Archaeological Overview Assessment
RPA 1716: Terra Nova National Park Utility Systems Recapitalization
Terra Nova National Park (Newfoundland and Labrador)
Funding: To Be Determined

Prepared By: J. Higdon, Archaeologist, IACH Directorate
Date: May 15, 2019

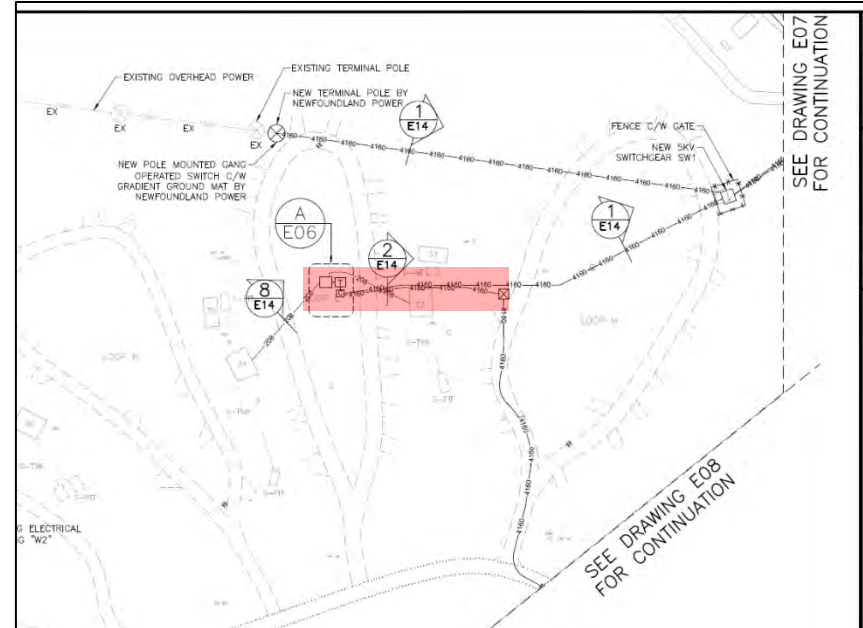
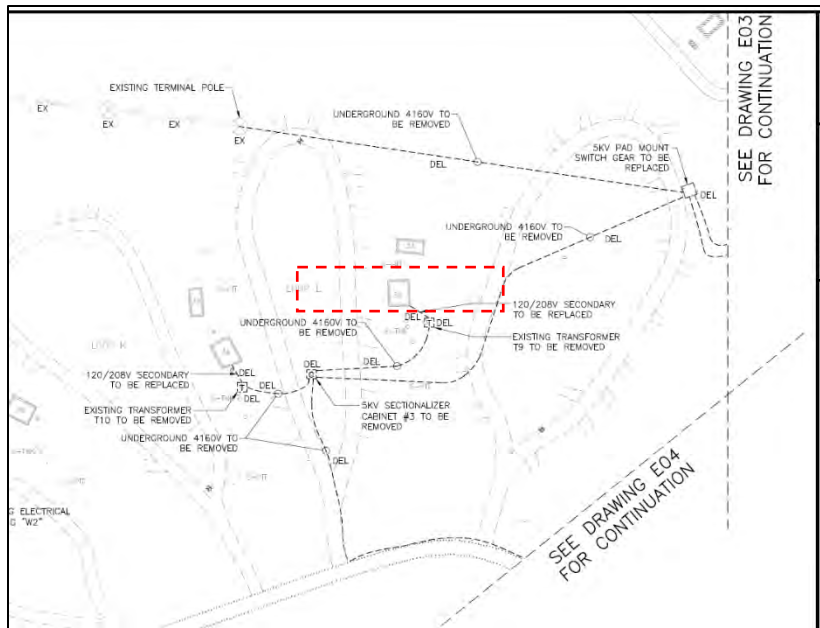
In sum, while some of the project areas are within 250m of Newman Sound, the bulk of the proposed work is set to occur within previously disturbed areas associated with existing power lines, related infrastructure and roadways. **An archaeological impact assessment is required, as two areas shown on E06 and E07 (Figures 2, 3 & 4) have been highlighted as areas of moderate potential. A site visit is required to determine if test pitting is needed.**

- E06 - Installation of new underground cable (Table 2, Figure 3).
- E07 - Installation of new underground cable (Table 2, Figure 4).

Figure 6: Newman Sound Campground Water, Wastewater & Water Storage Tank Recapitalization – Sanitary Sewer Overall Site Plan, Legend and General Notes. Red rectangles highlight approximate areas of interest. (Crandall 2019d:CS01)

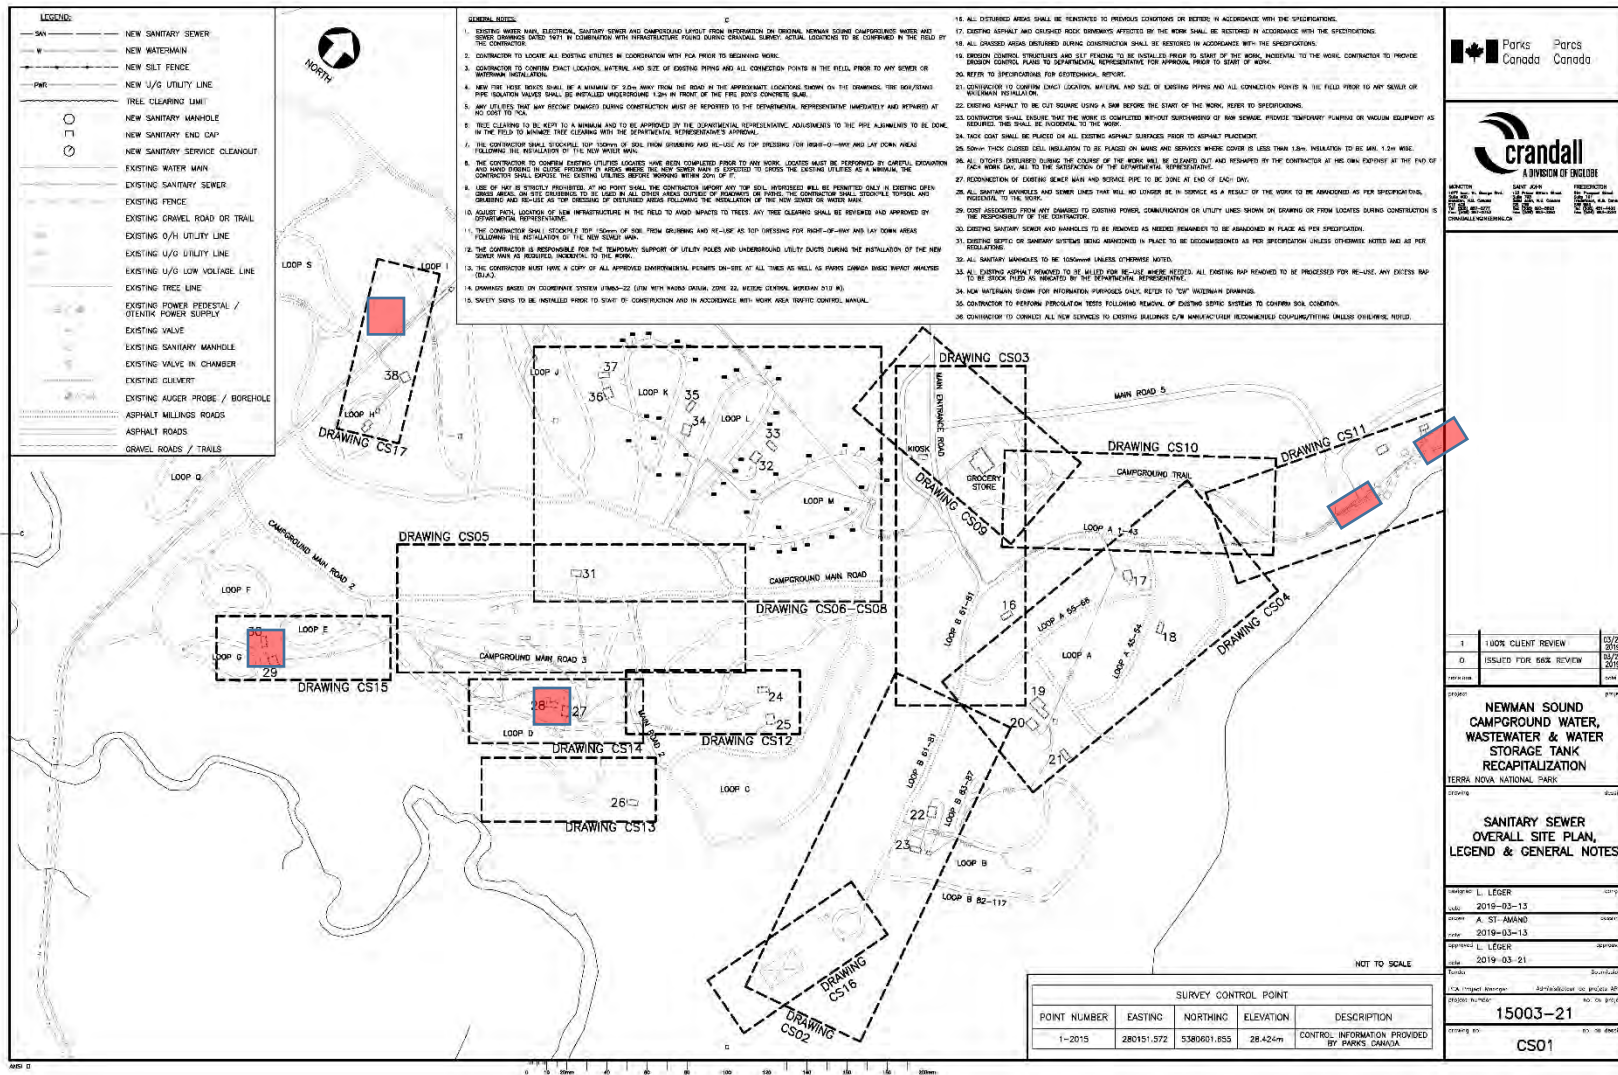
Sheet	Activity Impacting Ground Surface / Sub-Surface	Comments	AIA Required?
CW06	PVC Sanitary Pipe	Adjacent to existing waterline.	No
CS10 / CS11	New Watermain and Sanitary force main (~70m) (Figure 7)	Located 6m southeast of campground trail / parking lot. Unclear if this area was grubbed/graded as part of the construction of this campground / picnic area. Less than 50m west of Newman Sound.	Yes. Site Visit to see if judgemental test pitting is required.
CS12	New Septic Field (~20x25m)	~700m west of shoreline. Approx. 75% of the proposed field overlaps existing field, to be replaced, as needed. Area seems to have been disturbed with construction of existing field.	No
CS13	New Septic Field (~ 12x12m)	Over existing seepage pit. While the proposed area is over twice the size of the old pit, excavation in proximity to the septic area may pose health risks.	No
CS14	New Septic Field (~ 20 x 20m) & New Line (~ 40m) (Figure 8)	Located in seemingly undisturbed area.	Yes. Site Visit to see if judgemental test pitting is required.

Figure 9: New septic field and related lines. Red rectangles highlight project areas outside disturbed roadway and other previously disturbed areas (Crandall 2019d: CS15).

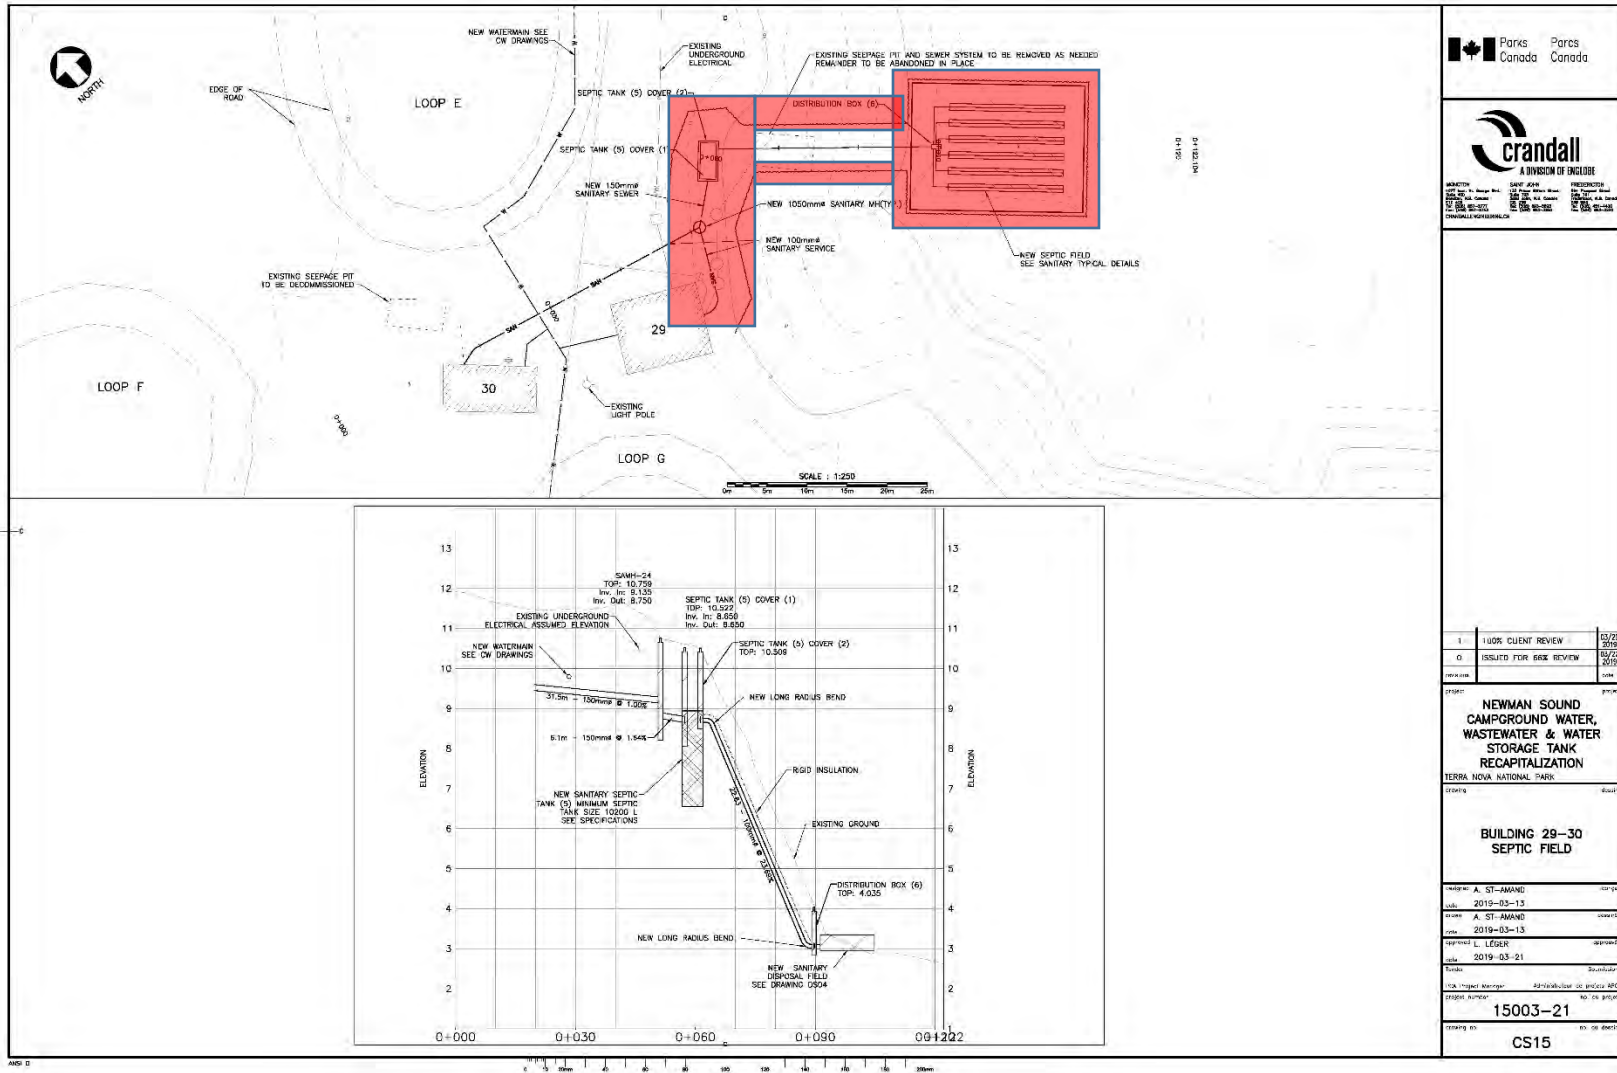
CS15	New Septic Field (~ 20 x 25m) & new lines (~30m) (Figure 9)	Located in seemingly undisturbed area.	Yes. Site Visit to see if judgemental test pitting is required.
CS16	New Septic Field (~25x40m) & new lines (~40m)	New Septic Field atop existing septic field. Area disturbed. While one new line appears to be in an undisturbed area, the slope suggests that this area is of lower archaeological potential. The remaining sections of the line intersect previously disturbed areas.	No
CS17	New Septic Field (~15x25) (Figure 10)	South half overlaps with existing septic field.	Yes. Site Visit to see if judgemental test pitting is required.

- CS14 - New Septic Field & Waterline (Table 3, Figure 8).
- CS15 - New Septic Field & Waterline shown in CS15 (Table 3, Figure 9).
- CS17 - New Septic Field (north half) shown in CS17 (Table 3, Figure 10).

Figure 12: Watermain Overall Site Plan (Newman Sound Campground Water, Waterwater & Water Storage Tank Recapitalization) (Crandall 2019d: CW01). Close up of areas of archaeological potential areas. Red = High, Yellow = Moderate.

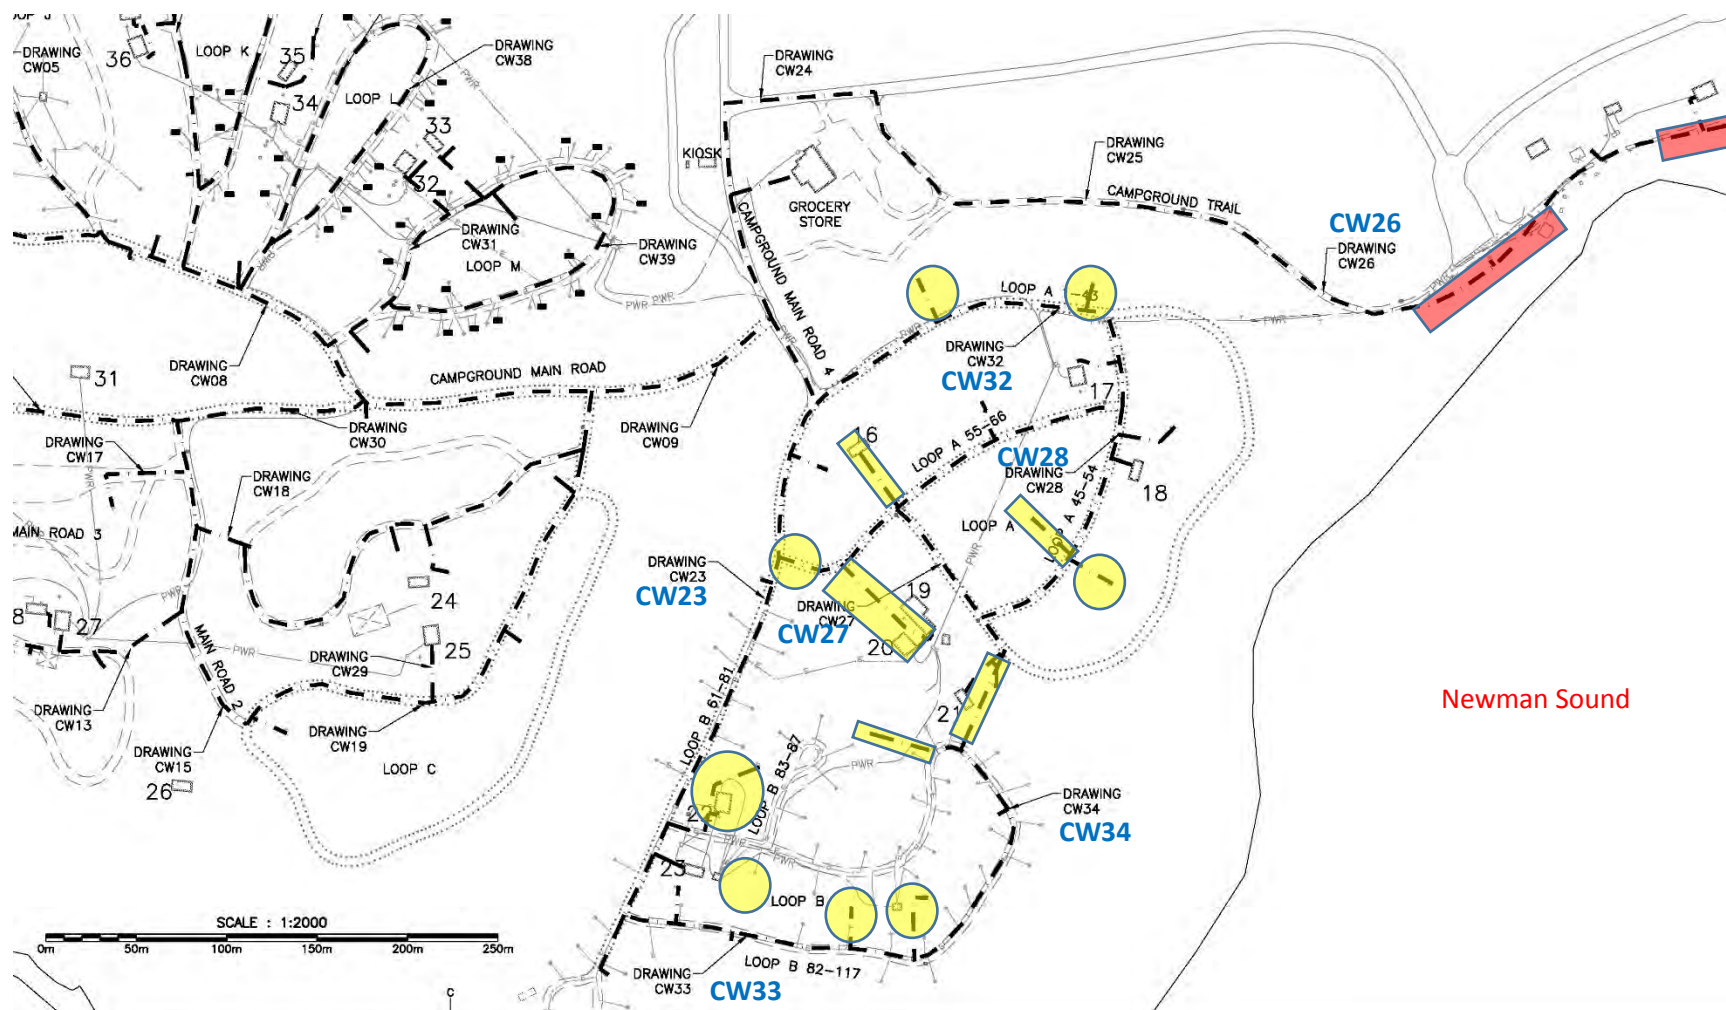
While any undisturbed area has some potential for unknown archaeological resources, areas within 300m of the ocean have been flagged as having moderate and high archaeological potential (Figures 11 & 12, Table 4)

Figure 13: Campground Main Road 4 Watermain Plan and Profile. Yellow lines highlight proposed excavations in undisturbed locations of moderate archaeological potential. (Crandall 2019d: CW23)

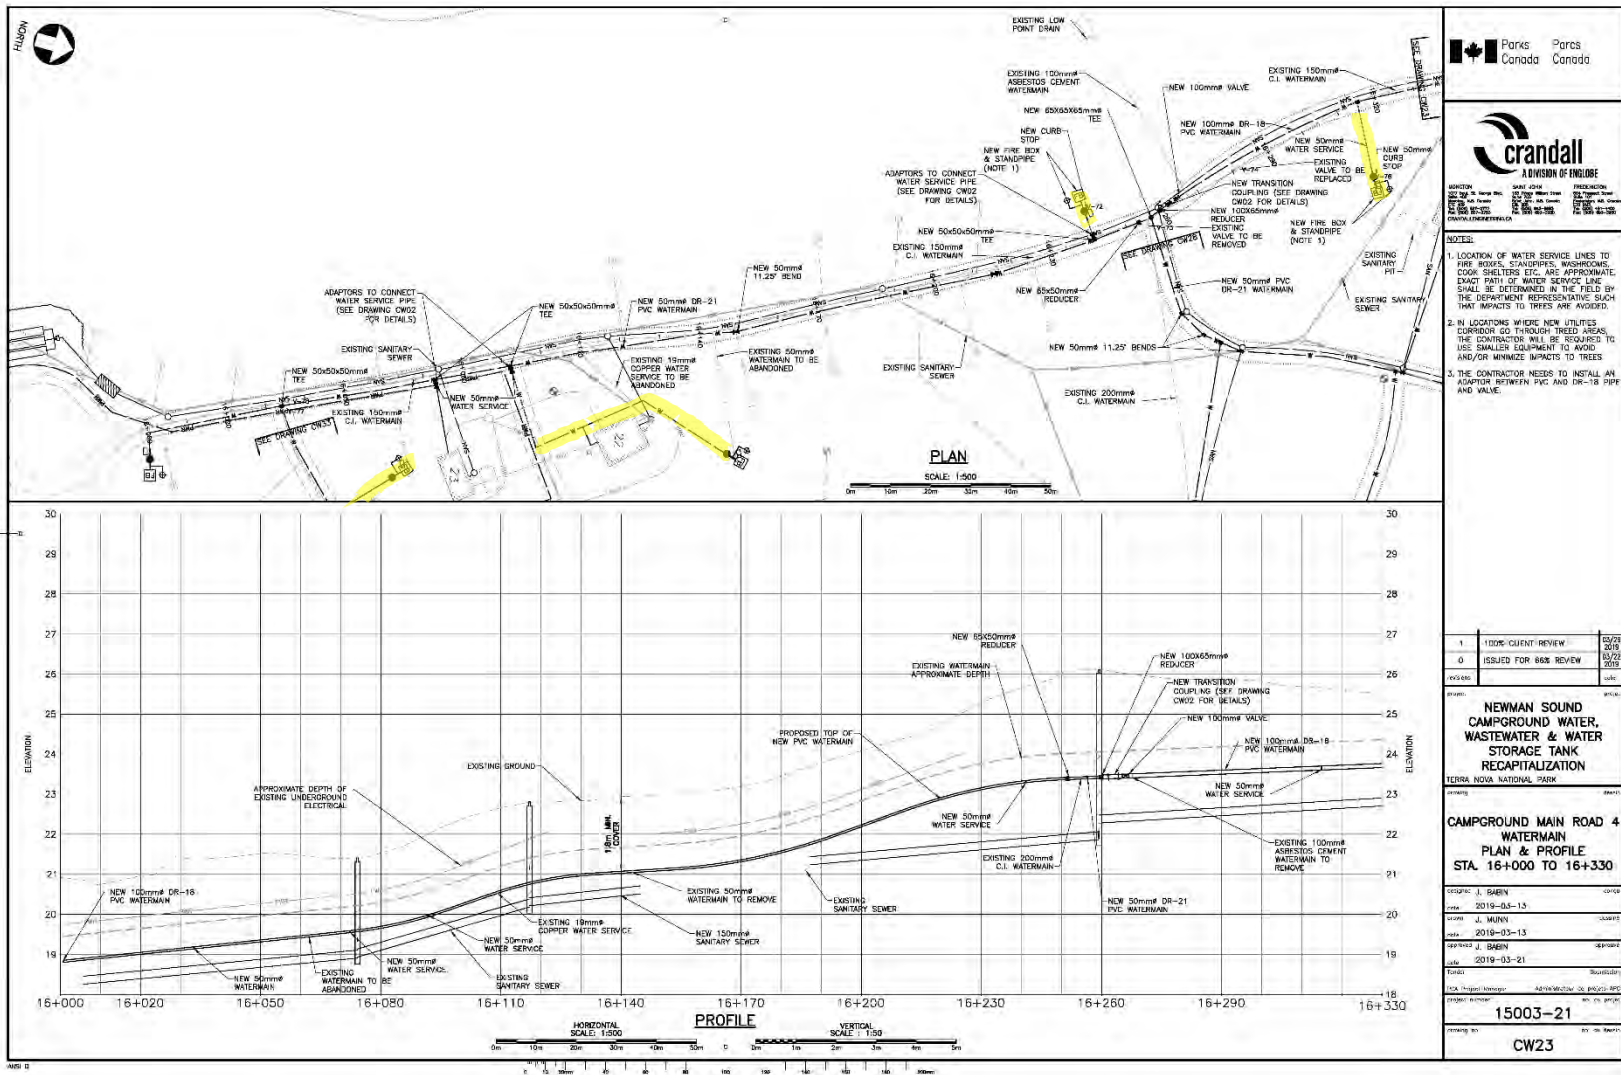
Sheet	Activity Impacting Ground Surface / Sub-Surface (approx. length)	Comments	AIA Required?
CW23	Watermain (60m) and Firebox (Figure 13).	Moderate archaeological potential. <250m west of Newman Sound.	Yes. Site Visit to see if judgemental test pitting is required.
CW26	Watermain & Forcemain (75m, 20m, 20m, 40m), and 2 Fireboxes (Figure 14).	High archaeological potential. Located at the Day Use Area, southeast of the trail and parking lot and 20-40m east of Newman Sound. Portions of proposed work lie outside of existing watermain footprint. That being said, this area could have been grubbed during the levelling of the area for use as a day use area. <i>The areas of concern in this area overlap with the areas of concern listed in Table 3, Sheet CS10 / CS11.</i>	Yes. Site Visit to see if judgemental test pitting is required.
CW27	Watermain (2 x 50m, 2 x 20m, 10m) and 4 Fireboxes (Figure 15).	Moderate archaeological potential. ~250m west of Newman Sound	Yes. Site Visit to see if judgemental test pitting is required.

- CW23 - Watermain and Firebox installation (Table 4, Figure 13).
- CW27 - Watermain and firebox installation (Table 4, Figure 15).
- CW28 - Watermain / water service & Fire Box (Table 4, Figure 16).
- CW33 - Watermain / water service, sanitation line, power line and fireboxes (Table 4, Figure 17).
- CW34 - Watermain / water service, sanitation line and fireboxes (Table 4, Figure 18).

Figure 14: Campground Trail Watermain. Red lines highlight proposed excavations in undisturbed locations of low archaeological potential. (Crandall 2019d: CW26)

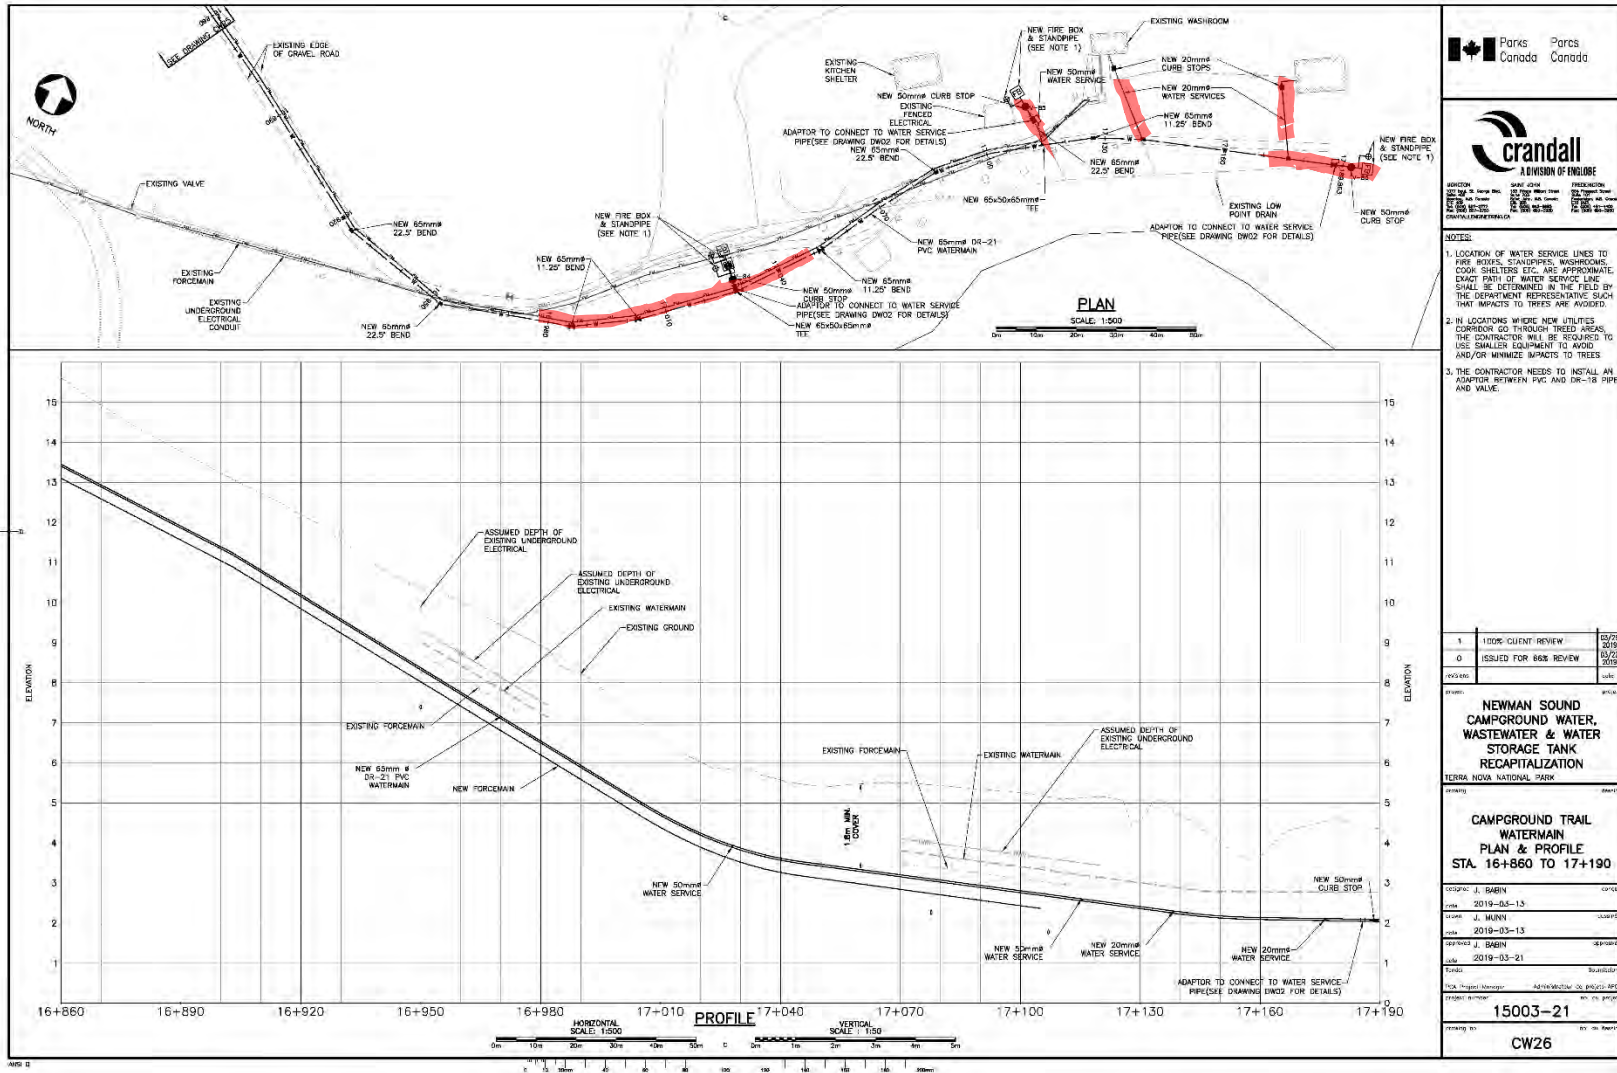
- **Project:** Newman Sound Campground Water, Wastewater & Water Storage Tank Recap (Crandall 2019c)
- **Summary:** Watermain, sanitary force main and fire boxes to be installed in previously undisturbed area.
- Project activities are outlined in section 3.3; Crandall 2019c: CS10/11 (Table 3, Figure 7) and Crandall 2019c:CW26 (Table 4, Figure 14).
